Memo

Planning Application Ref: PL/25/0422

Address: 92 Albert Road, Caversham, Reading

Proposal: Erection of detached dwelling

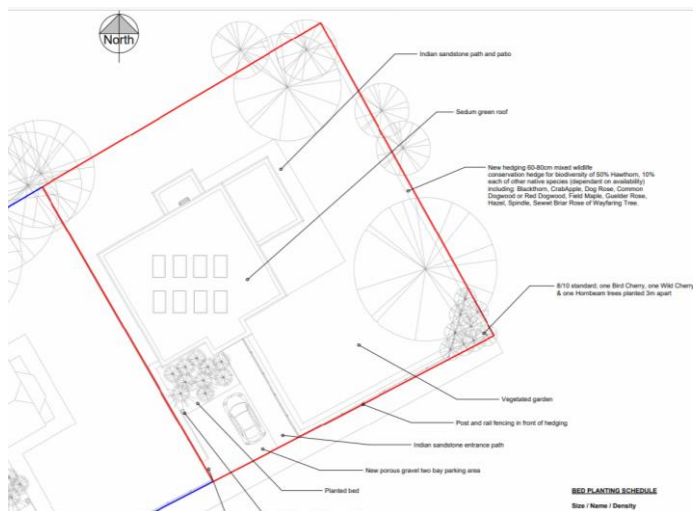
Previous planning proposals on this site have not been successful. Application 240496 (Extension and alterations to flats 1 & 3 to create one additional apartment) was withdrawn. Application 231265 (Erection of 4no.dwellings following demolition of existing

buildings) was refused, with RfR 4 (amenity space provision) & 9 (pressure on trees) relating to tree issues, with plans showing the following:

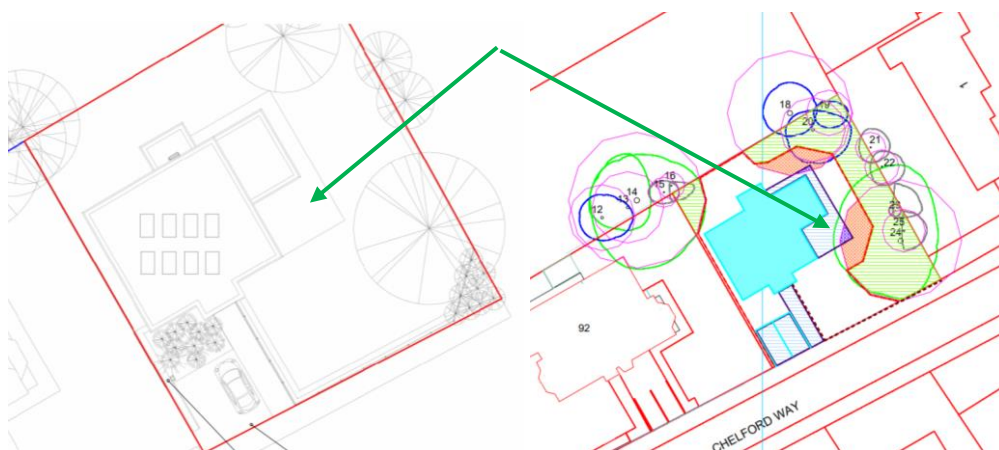
The acknowledgement that the tree(s) will need pruning in the future does not take the above advice into account and indicates that insufficient space has been provided for future growth.
